Access Compliance Report Public Rights-of-Way (Curb Ramps)

Main Street: **REGENT_PARK** Cross Street: **CHARDONNAY_DR** Location: **NW**

ADA ID: **RPAT211103134450** Ramp Type: **Type 1 - Perpendicular Diagonal** Initial Pass/Fail: **Fail** Overall Compliance: **No** Severity Score: **30**

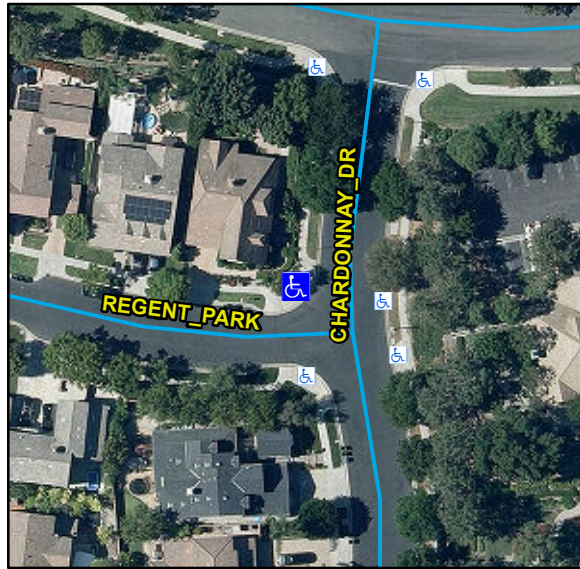
Compliance	Description	Data	Compliance	Description	Data
N/A	Ramp Length (in)	89	N/A	Flare Type LT	
Yes	Ramp Width (in)	50			N/A
Yes	Ramp Run Slope (%)	2.5	N/A	Flare Slope LT (%)	N/A
No	Ramp Cross Slope (%)	7.2	N/A	Flare Traversable LT	N/A
N/A	Landing Present	N/A	N/A	Flare Type RT	
N/A	Landing Length (in)	N/A			N/A
N/A	Landing Width (in)	N/A	N/A	Flare Slope RT (%)	N/A
N/A	Landing Run Slope (%)	N/A	N/A	Flare Traversable RT	N/A
N/A	Landing Cross Slope (%)	N/A	N/A	DWS Provided	N/A
N/A	Landing Movement Obstructed?	N/A	N/A	DWS Contrast	N/A
	Landing Movement Type	N/A	N/A	DWS Length (in)	N/A
N/A	Landing Shared	N/A	N/A	DWS Full Width	N/A
N/A	Clear Space	Yes	N/A	DWS Offset Left (in)	N/A
N/A	Clear Space To Crosswalk (in)	N/A	N/A	DWS Offset Right (in)	N/A
N/A	Marked Crosswalk 1	No	N/A	Marked Crosswalk 2	No
	Crossing 1 Direction	S		Crossing 2 Direction	E
	Marked Crosswalk 1 Width (in)	N/A		Marked Crosswalk 2 Width (in)	N/A

N/A	Ramp Inside Crosswalk 1	N/A	Yes	Ramp Inside Crosswalk 2	N/A
	Crossing 1 Slope (%)	0.7		Crossing 2 Slope (%)	1.3
	Crossing 1 Cross Slope (%)	3		Crossing 2 Cross Slope (%)	2.1
N/A	Gutter Ponding	N/A	No	Curb Slope	6.3
Yes	Gutter Lip Height (in)	0		Road Run Slope (%)	2.4
N/A	Gutter Run Slope (%)	N/A		Road Cross Slope (%)	0.6
N/A	Gutter Cross Slope (%)	N/A			
Yes	Overall Surface Condition: Acceptable		No	Perp Joint Present	No
	Cross Gutter Present?	No		Spandrel Present?	No
	Replace Cross Gutter?	N/A		Replace Spandrel?	N/A

Remove & Replace Curb Ramp With Two New Directional Ramps or Equivalent.

R304.2.2, R204.3, R304.5.3, STD 1115
